APPLICATION FOR A CERTIFICATE OF APPROPRIATENESS – STAFF REPORT

COA-0068-2019 1204 E LANE STREET

Nature of Project: Construct house with deck; construct garage; install driveway and fence; remove two trees, plant two trees; renew COA for garage demolition

**TYPICAL FENCE**  
**DETAILS**

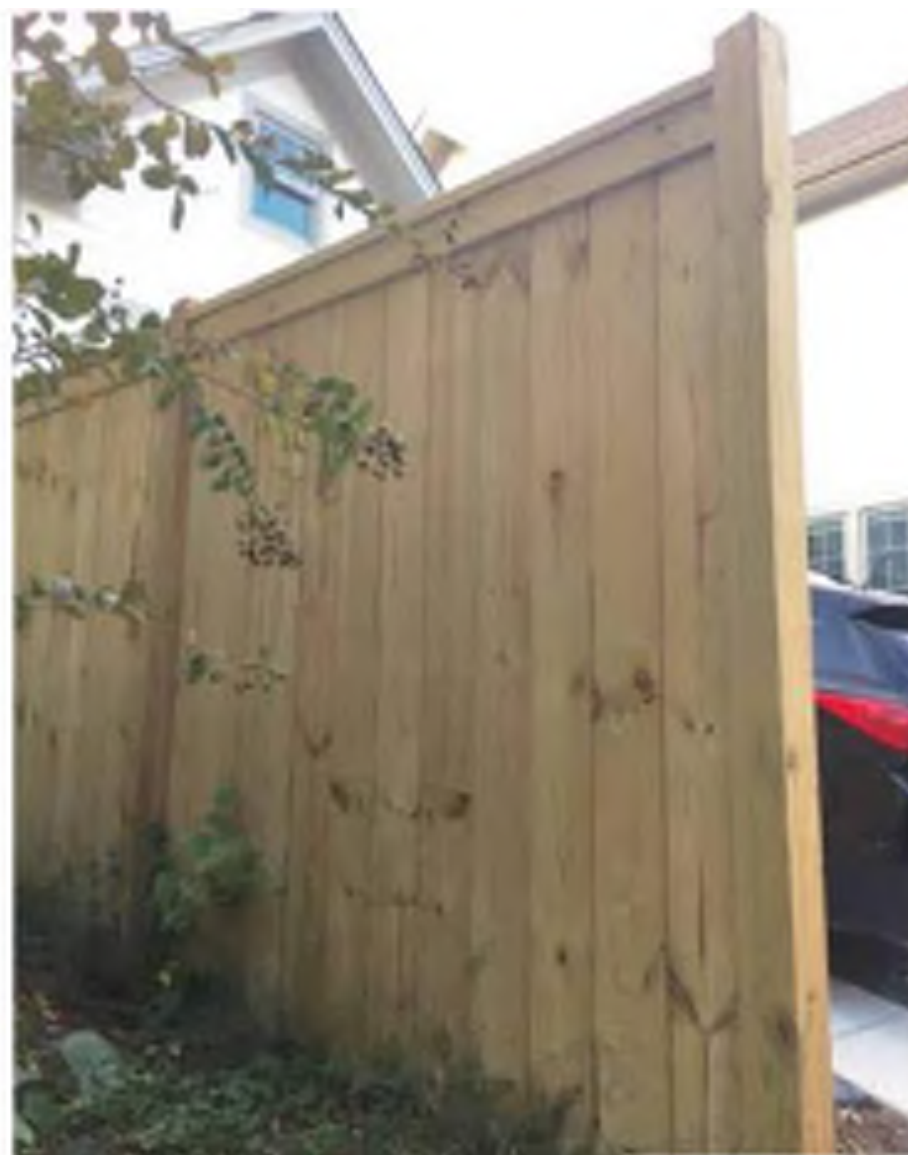
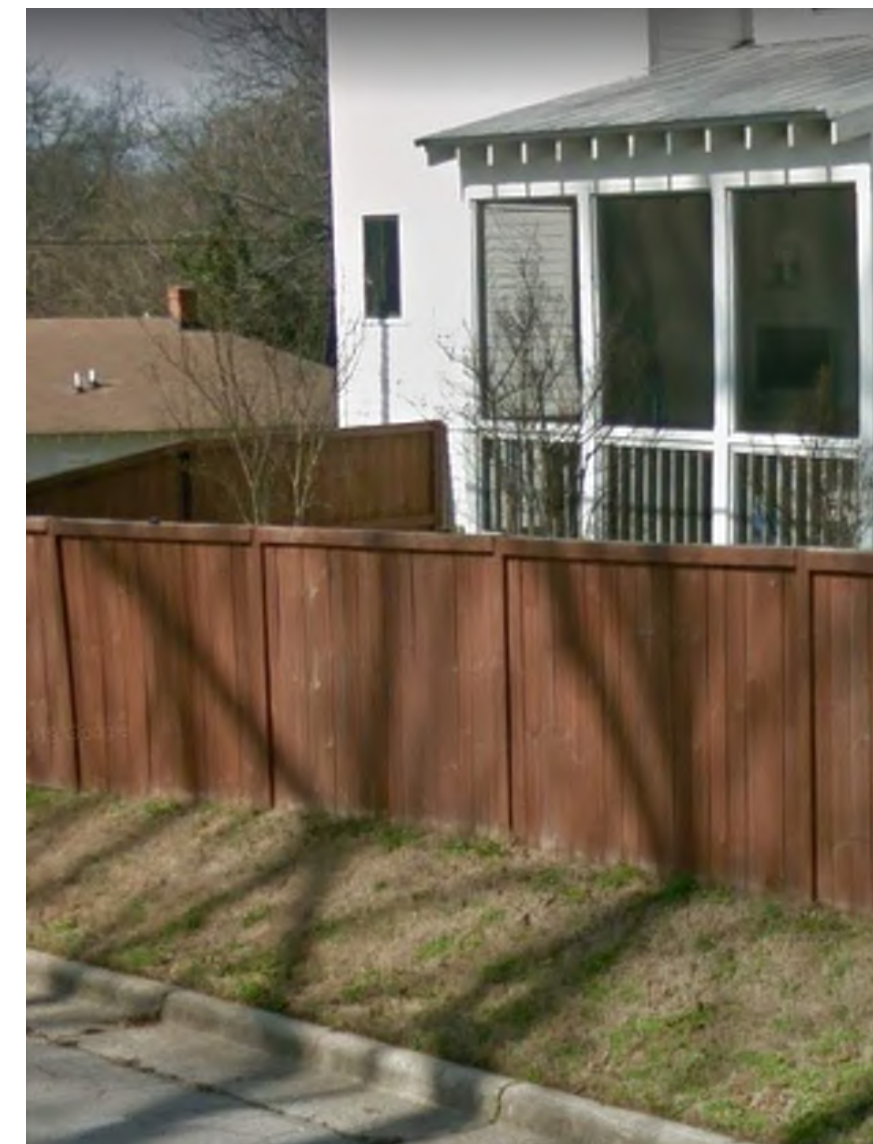
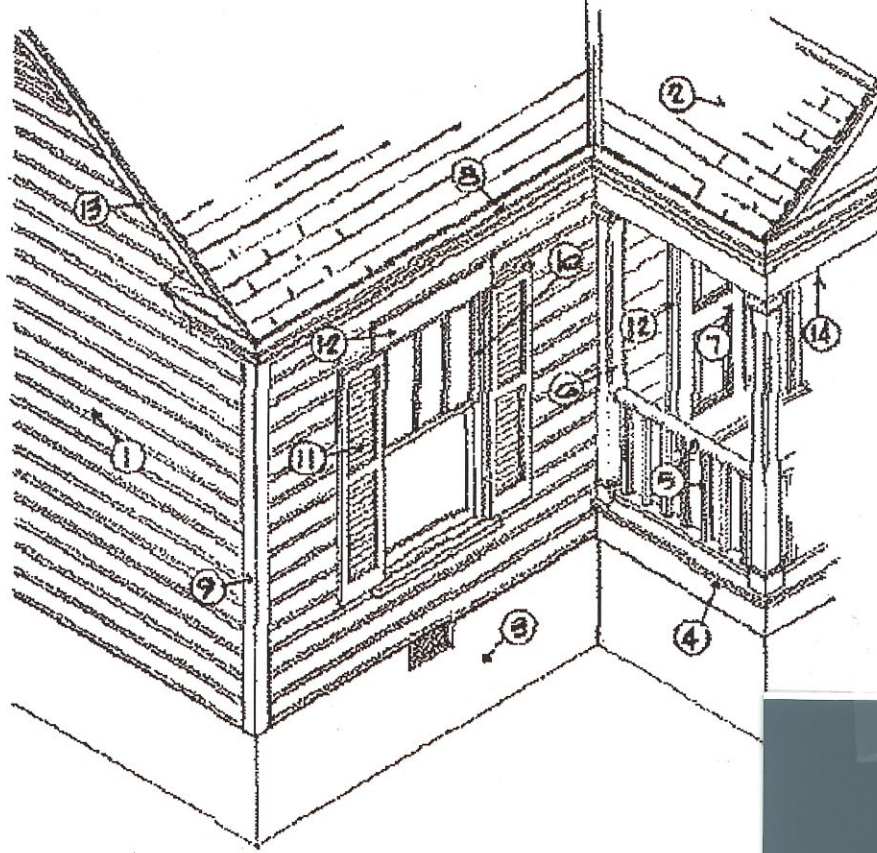
- 7\* The application includes the installation of a 6' wood fence and gate to enclose the rear yard. Photographs of the proposed design are included; however, the exact location and finish color of the fence and gate were not provided.

- 8\* The committee has regularly found that 6'-tall wood privacy fences meet the *Design Guidelines* when installed in rear and side yards (except for corner lots). Traditionally, fences were constructed with neighbor friendly design, with structural members facing inward; the proposed fence designs have the same appearance on each side.

- a. Species and size details for new trees;
  - b. Location and finish color of the fence and gate;
  - c. Roof material;
  - d. Front porch including the roof, floor, ceiling, pier and columns;
